KRONICK
MOSKOVITZ
TIEDEMANN
& GIRARD

May 28, 2026

Re: Allocating responsibility to achieve sustainability in 5-year Evaluation of GSP for Salinas Valley's 180/400-Foot Aquifer Subbasin

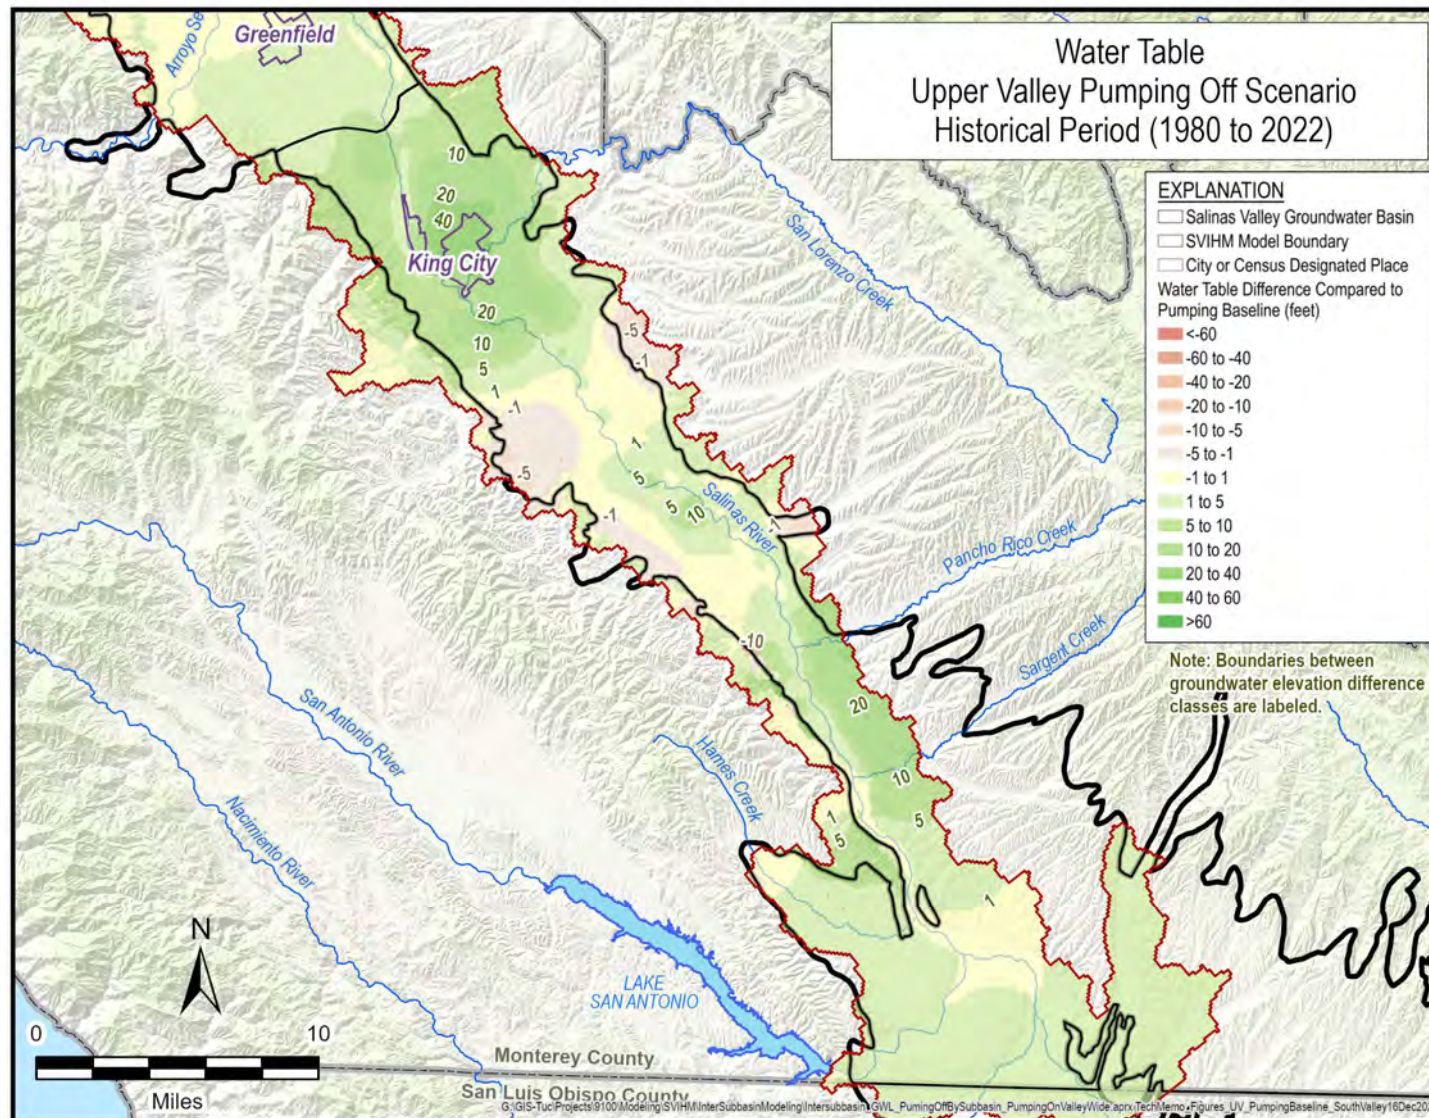
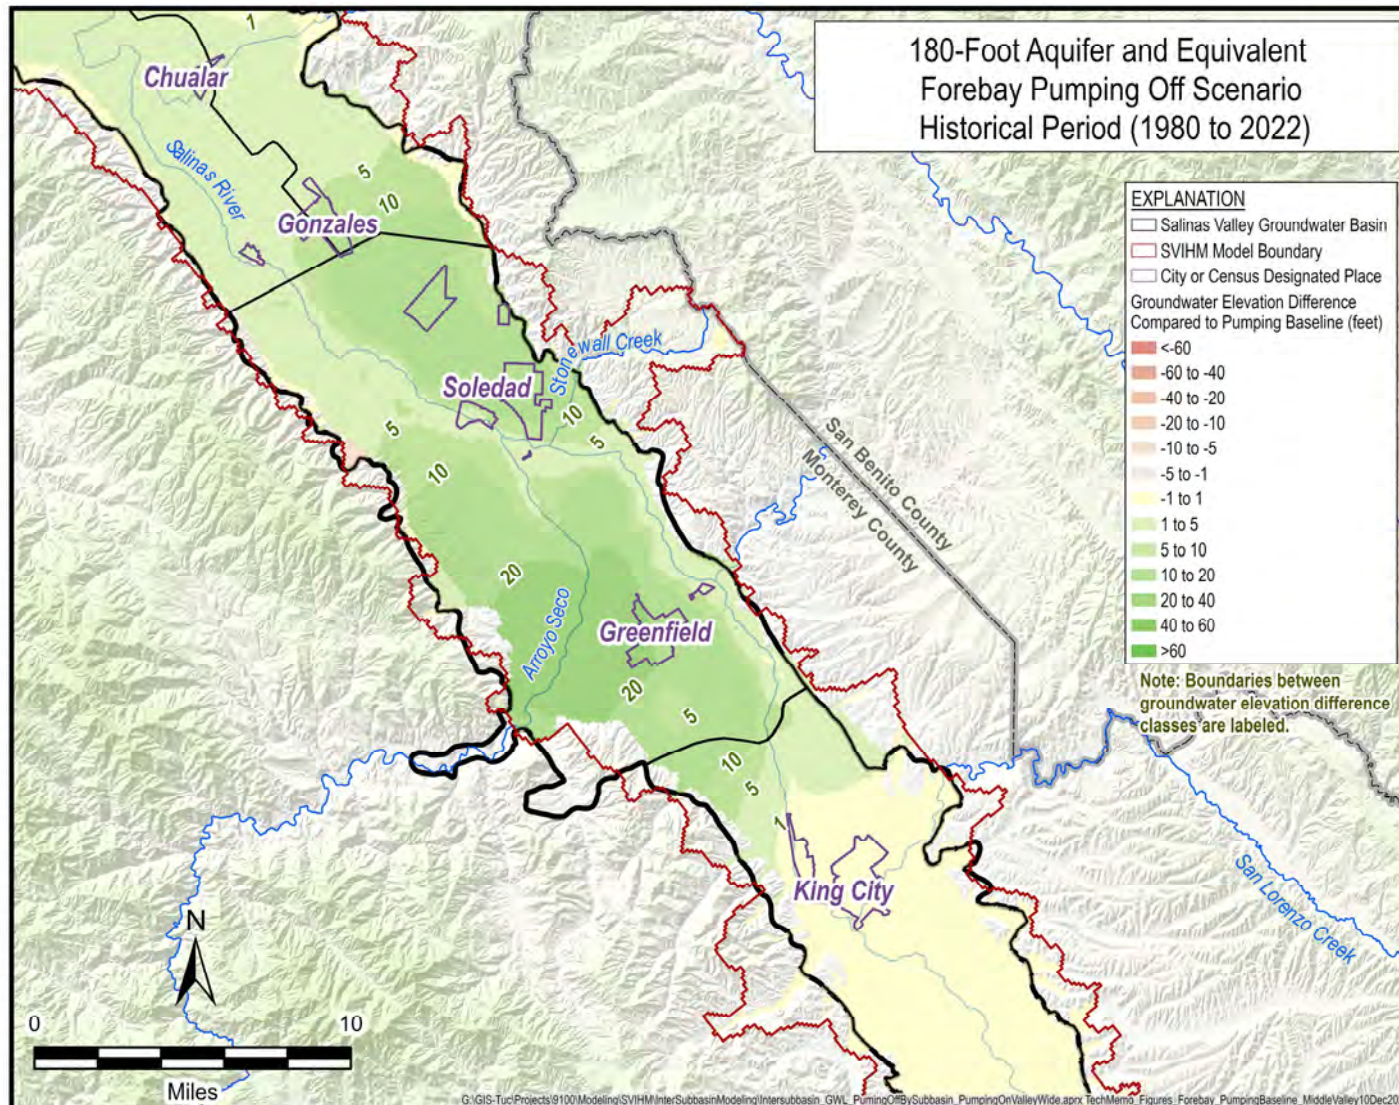
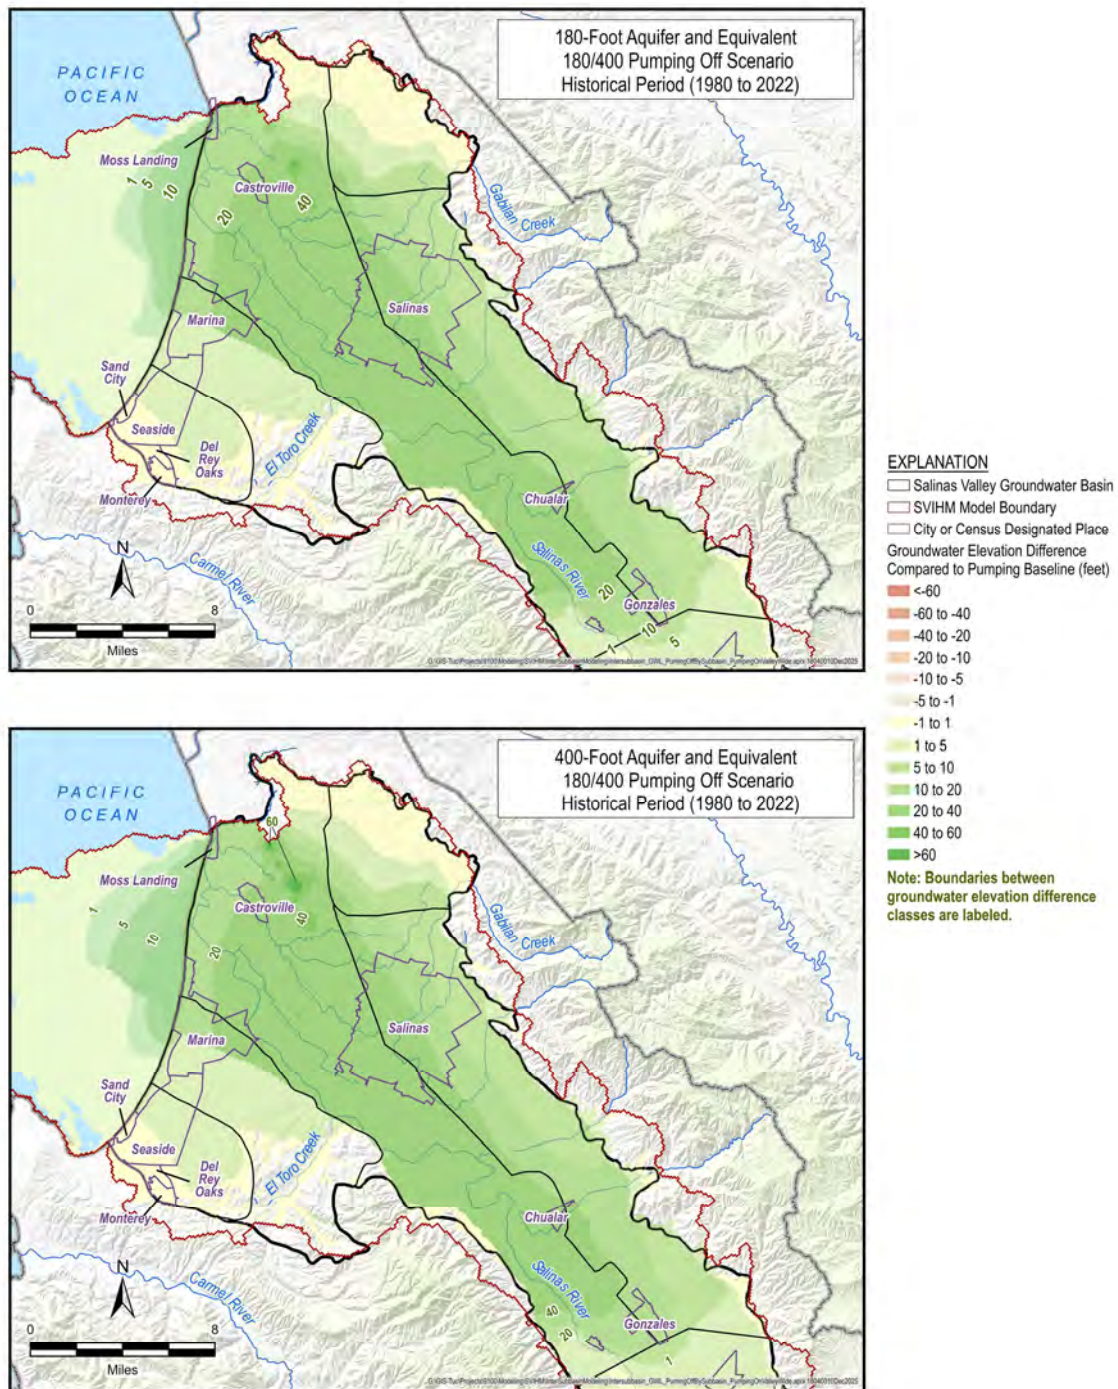
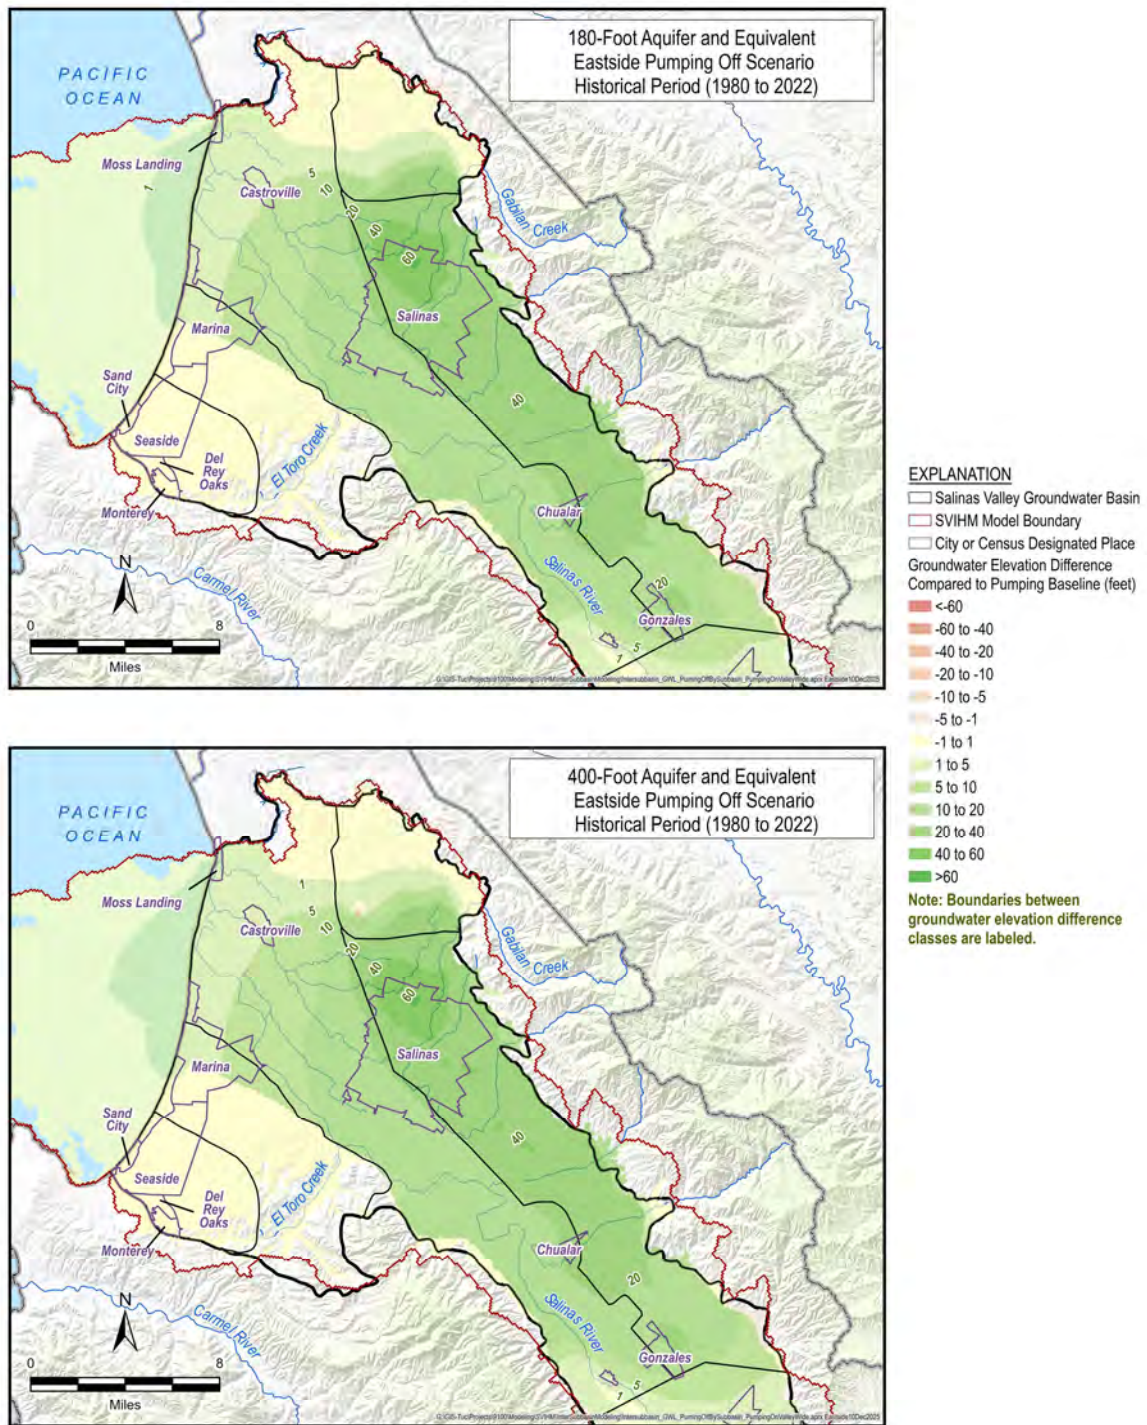
The figures in the draft M&A memorandum are generally informative. However, Figures 2 through 5 and Figures 9 through 12 do not show the results of interest. These figures show the groundwater elevation changes in the subbasin for which pumping was turned on or off. They do not show the impact of pumping in one subbasin on water availability in adjacent and downgradient subbasins. M&A provided draft "replacement figures" at **aquilogic's** request but did not update their draft memorandum.
